DOCUMENT NO: OP-1903.043

TITLE: DUTIES OF THE EMERGENCY RADIATION TEAM

REVISION NO: 019-00-0

ENTERGY OPERATIONS INCORPORATED
ARKANSAS NUCLEAR ONE

CONTROL ROOM RADIOLOGICAL MONITORING GUIDELINES

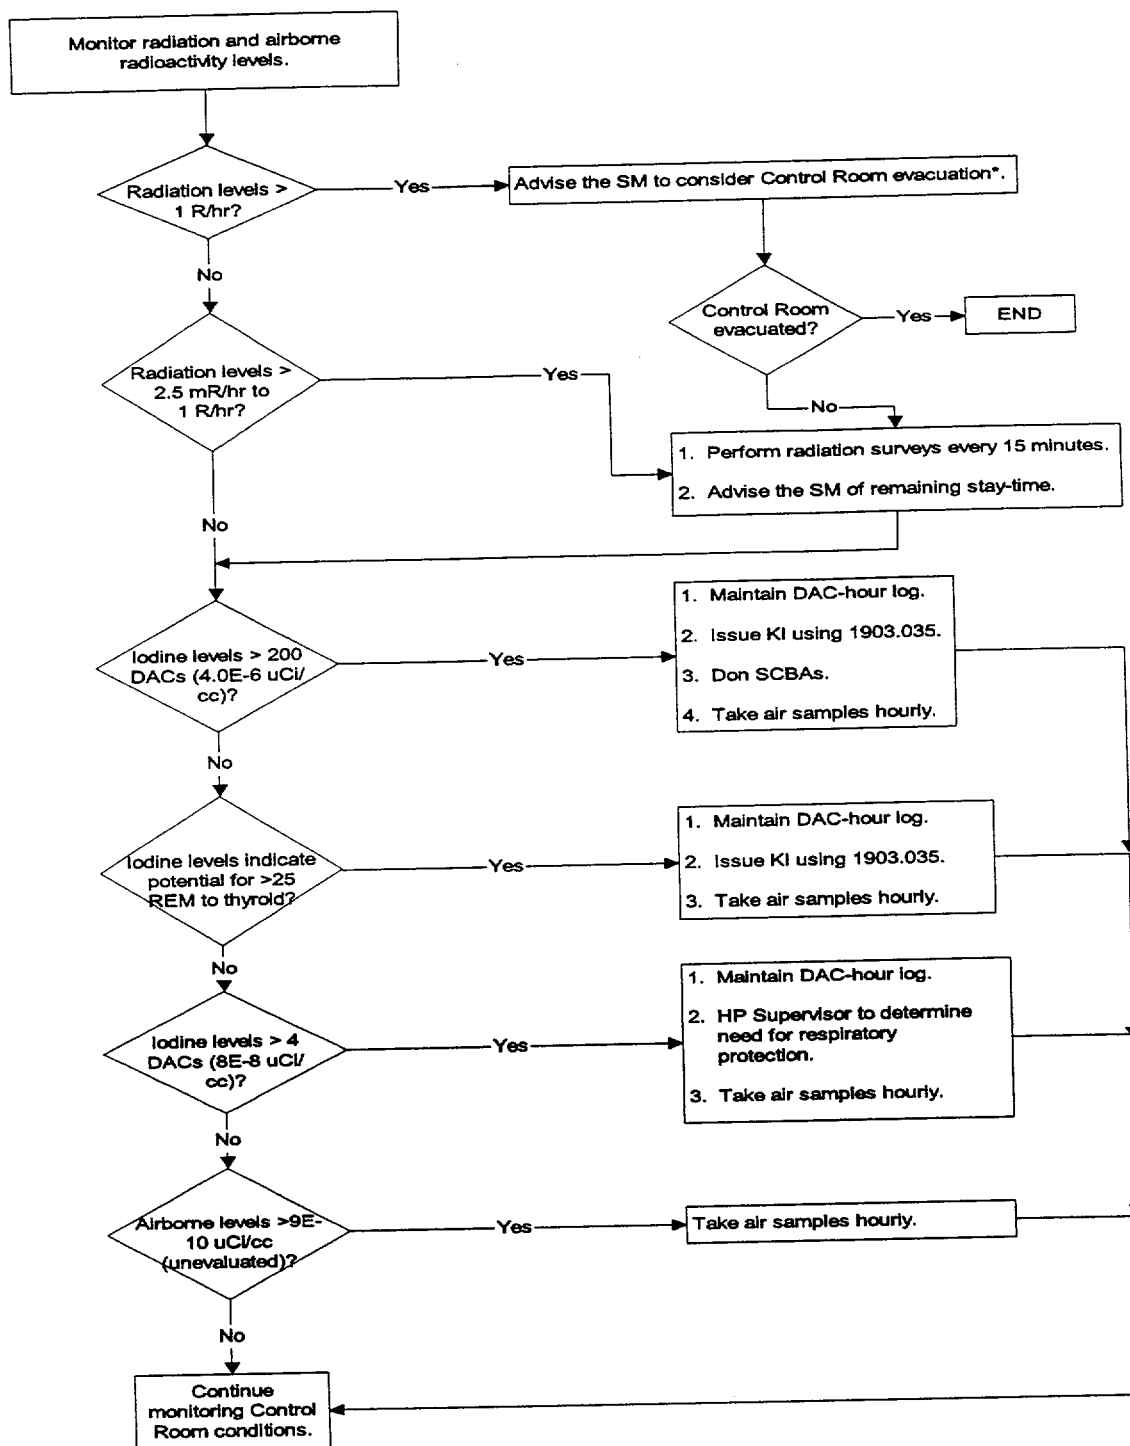
7.7.11	Deleted reference to 1905.032. Procedure no longer exists.		
Attachment 1	Re-formatted flowchart and added action steps for issuance of KI and use of SCBAs.		
FORM TITLE: DESCRIPTION OF CHANGE		FORM NO. 1000.006C	CHANGE NO. 050-00-0
